JOINT REGIONAL PLANNING PANEL
(East Region)

JRPP No	2012SYE053
DA Number	DA-12/070
Local Government Area	City of Botany Bay
Proposed Development	Construction of 141 residential apartments arranged in three separate building forms above a common basement providing parking for a total of 255 cars and loading facilities and associated landscape treatment
Street Address	22-24 Rhodes Street, Hillsdale
Applicant	Krikis Tayler Architects
Number of Submissions	Nil
Recommendation	Approval – Deferred Commencement
Report by	Rodger Dowsett, Director Planning and Development

Figure 3 Site Plan showing arrangement of built form and view corridors

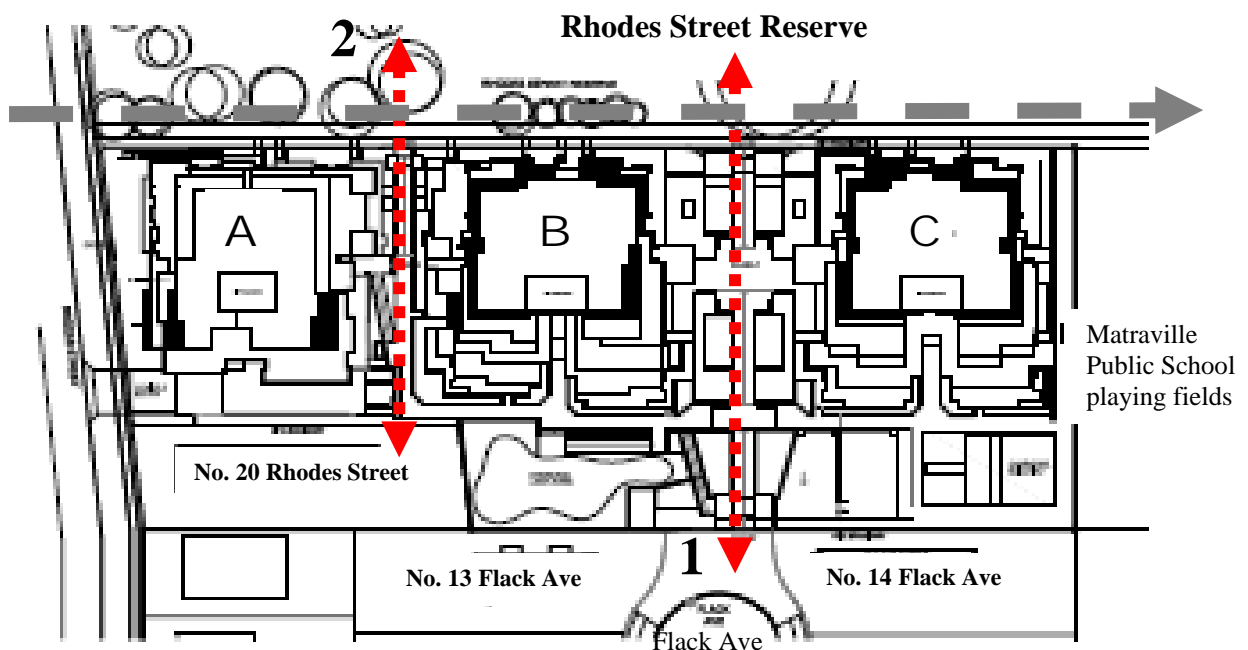
The site is bisected by two (2) north-south pedestrian connections. The primary link (marked “1” on **Figure 3** and identified as Plaza 1 in the architectural drawings) is intended to provide public access and function as a through-site link between the northern end of Flack Avenue and Rhodes Street Reserve.

The secondary connection (marked “2” on **Figure 3** and identified as Plaza 2 in the architectural drawings) is located between Buildings A and B and is provided for the use of residents of the complex, providing a direct connection to Rhodes Street Reserve, as well as the communal open space and Plaza 1 and Flack Avenue. Security gates will be installed at the northern end of Plaza 2 (where it interfaces with Rhodes Street Reserve) and at the junction with Plaza 1 to prevent public access to the private areas of the proposed development.
